Council Assessment Panel of City of Prospect

- 5.1 225 Prospect Road, Prospect - Three Storey Residential Flat Building comprising 17 Dwellings with associated Retaining Walls, Fencing and Landscaping (DA 050/287/2017)

From: Scott McLuskey, Senior Development Officer, Planning

DRAWING TITLE
DRAINAGE PLAN

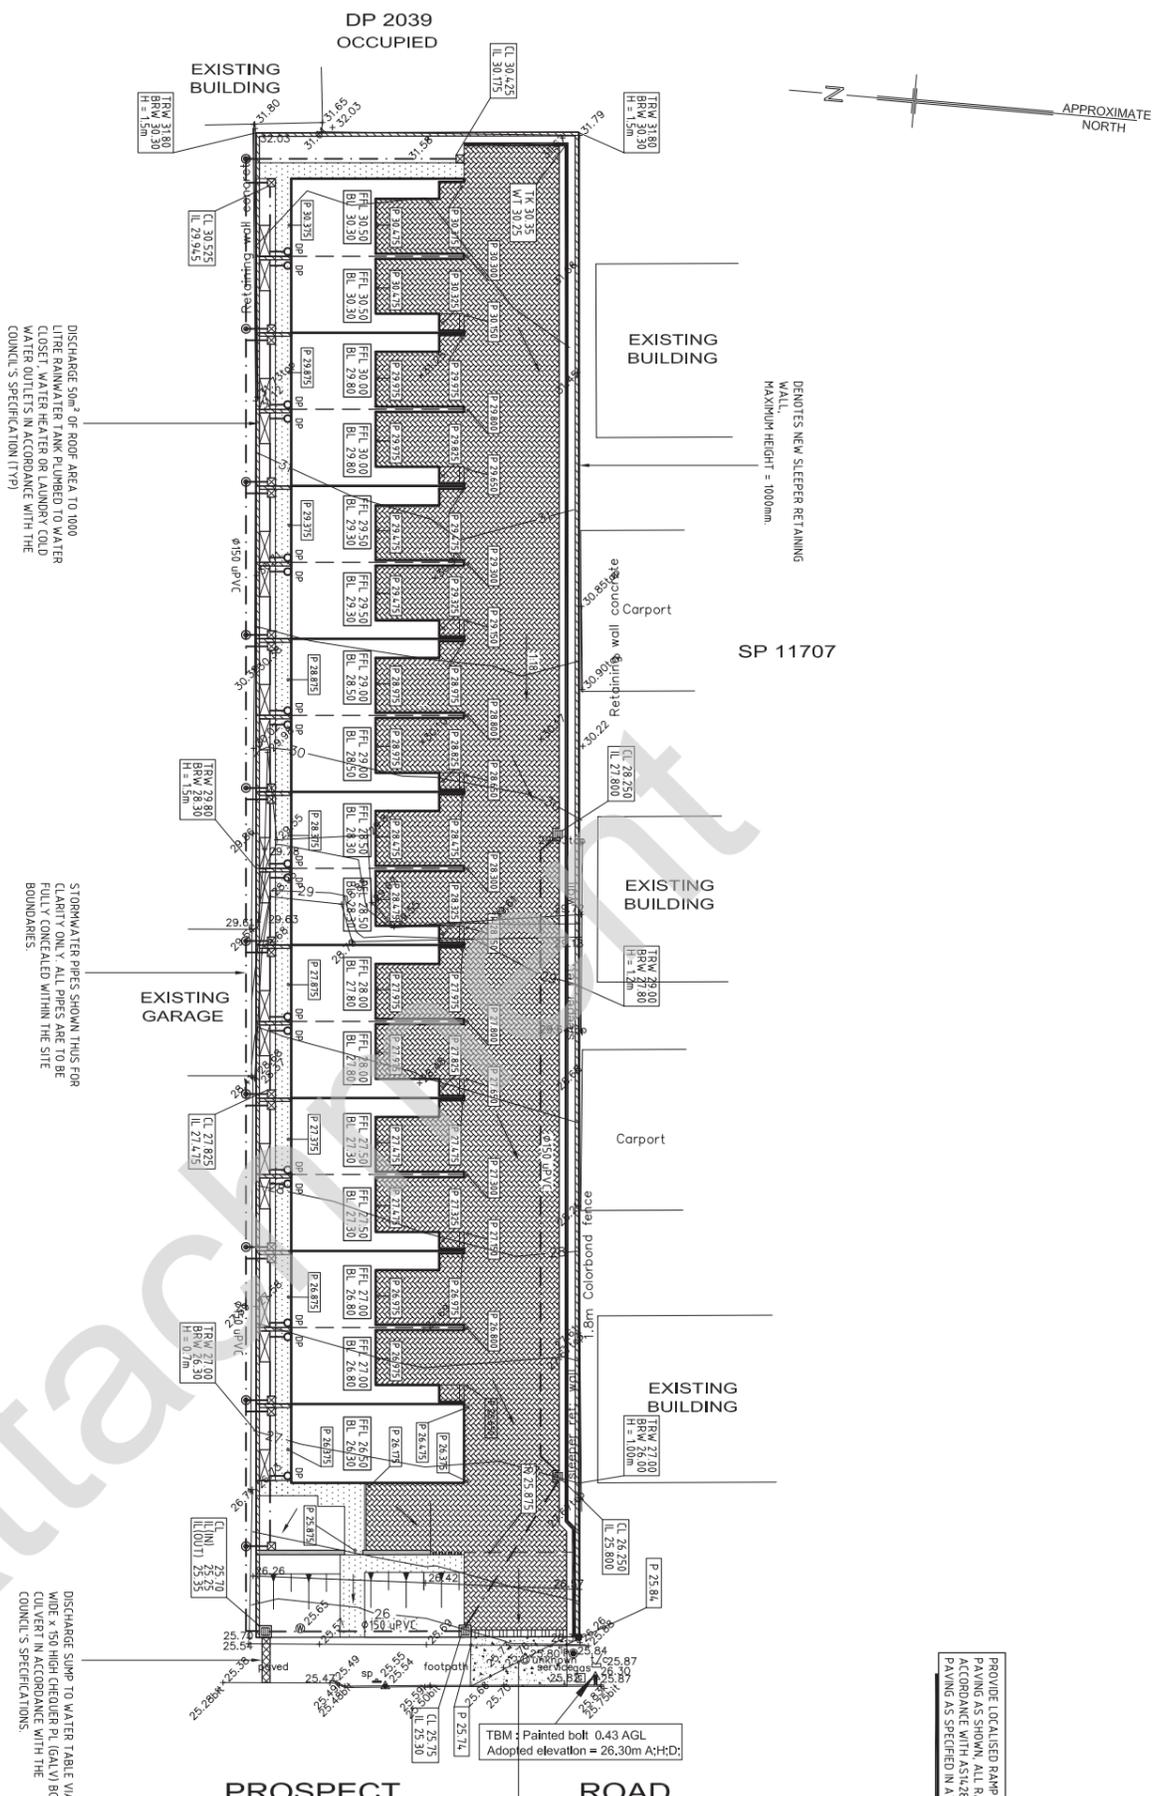
- 7.10.2 A civil engineering plan has been provided, demonstrating the intended configuration of the stormwater system. 1,000L rainwater tanks are proposed to the rear of each dwelling that would collect water from each dwelling roof in accordance with the Building Code of Australia. It is noted that this does not agree with the floor plans provided, which show the location of the rainwater tank within the garage of dwellings 2-17.

- 7.10.3 Noting this discrepancy and given that the proposal would result in an increase in stormwater run-off from common driveway areas, it is fundamental that Council receive and assess a detailed plan including the details of the post-development outflow rates, though it is considered that opportunities for any necessary detention on-site are readily available within the common driveway.

- 7.10.4 It is therefore recommended that the consideration of the stormwater design could be reasonably reserved for further assessment and approval by Council should development plan consent be granted.
